RECOMMENDATION REPORT

Los Angeles City Planning Commission

Case No.: CPC-2010-1554-DB-SPP
CEQA No.: ENV-2012-110-EIR
(SCH No. 2012031014)

PROPOSED PROJECT: The site is comprised of three (3) lots; two (2) lots are located along Serrano Avenue and one (1) lot is located on Hobart Boulevard. The project proposes the demolition of four (4) existing two-story apartment buildings and the relocation of two (2) existing 1-story bungalow structures to a location along Serrano Avenue. The two bungalow structures contain three (3) dwelling units which would remain. The project also involves the construction of a new 51-unit multi-family building with a maximum height of 45 feet. At the ground level and above, the 51-unit project is designed as two residential buildings with a shared subterranean level of parking. The subterranean parking level would contain 56 parking stalls. The project would result in total of 54 dwelling units with approximately 46,353 square feet of floor area. All the proposed units would be reserved as affordable units excluding one (1) unrestricted manager's unit.

NORTH ELEVATION
3/32" = 1'-0"

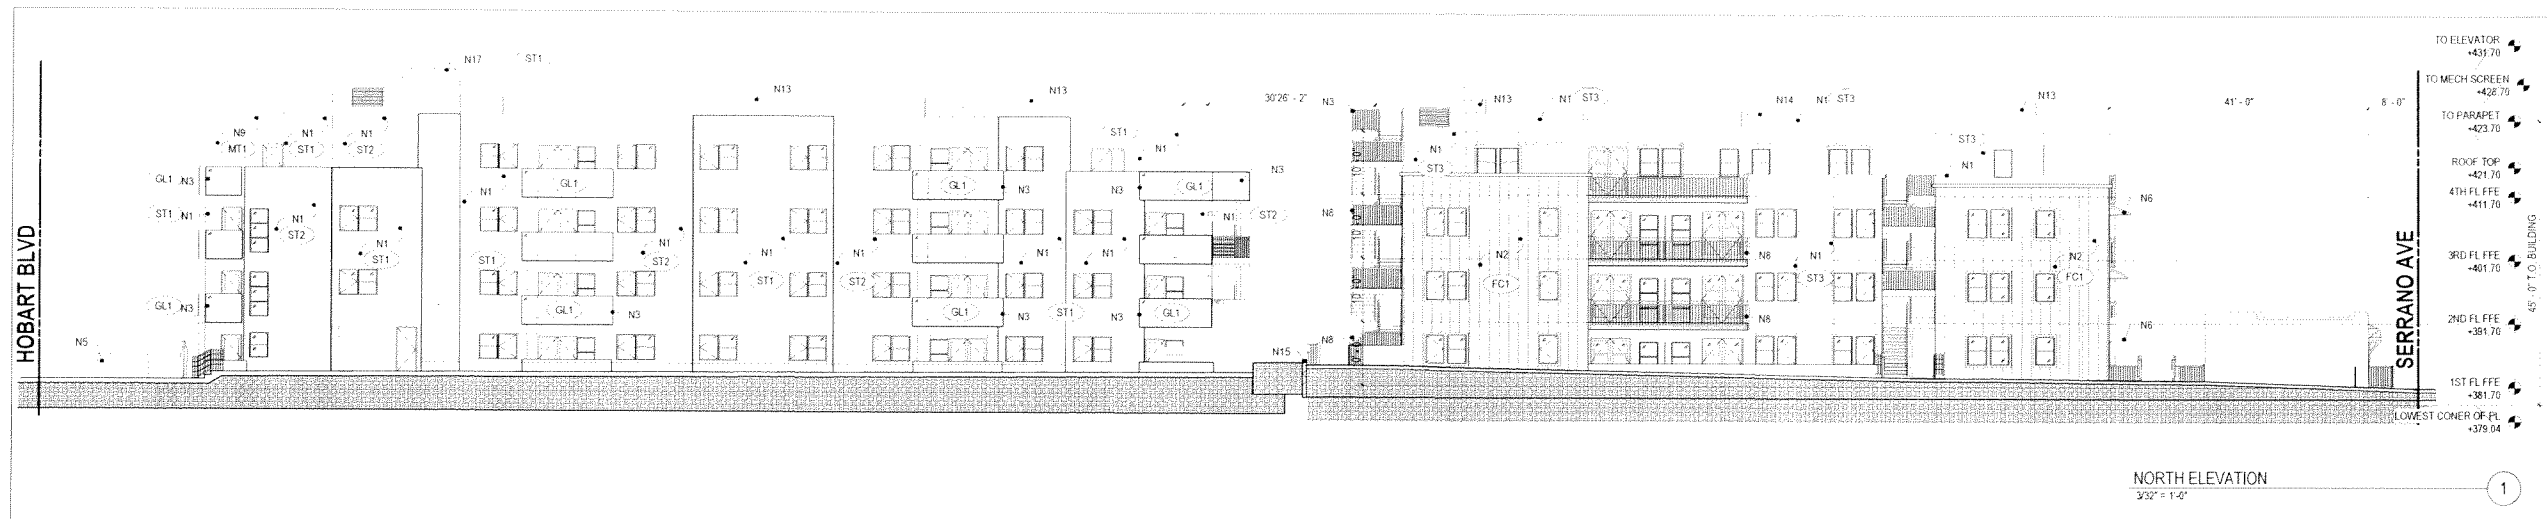
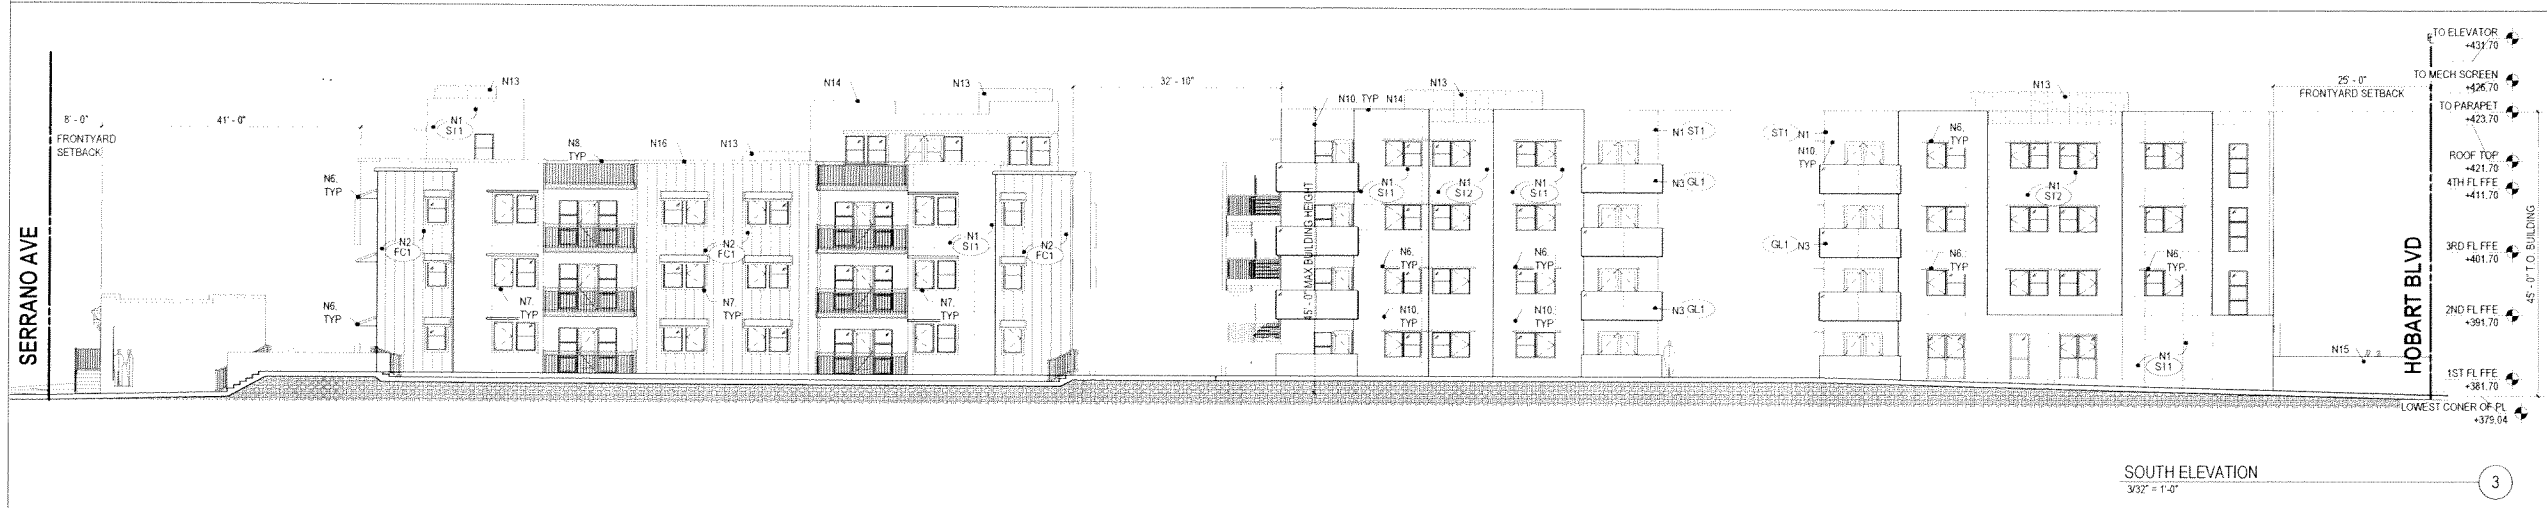
- A row of trees should be added to the southern strip of open space along the south property line. These trees should have the same fullness as that shown in the Serrano elevation for the "Sweet Shade" trees. This will mitigate heat and also will mitigate the scale of the building for the adjacent lower bungalow courts.

These comments were conveyed to the applicant. The project plans have been revised to include material choices. The choice of trees have remained the same as the applicant has confirmed that the tree choice will match the rendering. Conditions of Approval are included to require any fences, gates or free standing walls to be located behind the façades of the buildings.

PERIMETER FENCE / WALL DETAIL
3/8" = 1'-0"

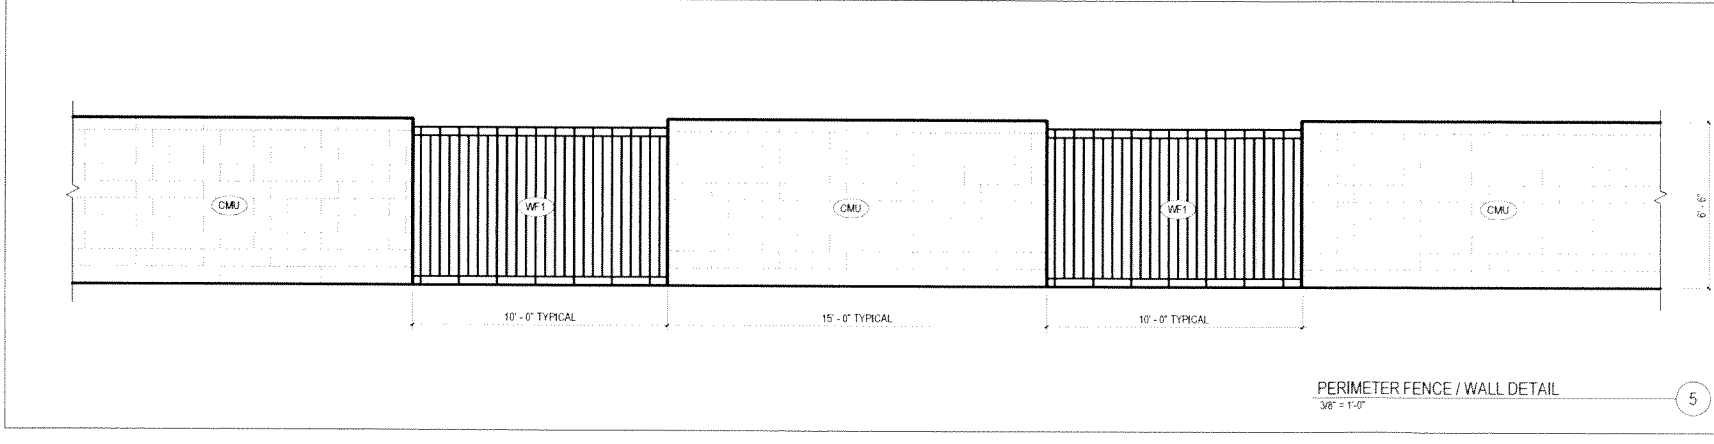
- Serrano Avenue fencing - the gate in between the bungalows should be recessed from the face of the bungalows a few feet. Fencing / gates should be added to both north and side yard open space areas and this fencing should be similarly recessed from the face of the bungalow.

- Hobart Boulevard fencing - the proposed fencing (which appears on the landscape plan but not the site plan) should be removed. In its place could be a fence/gate on both the
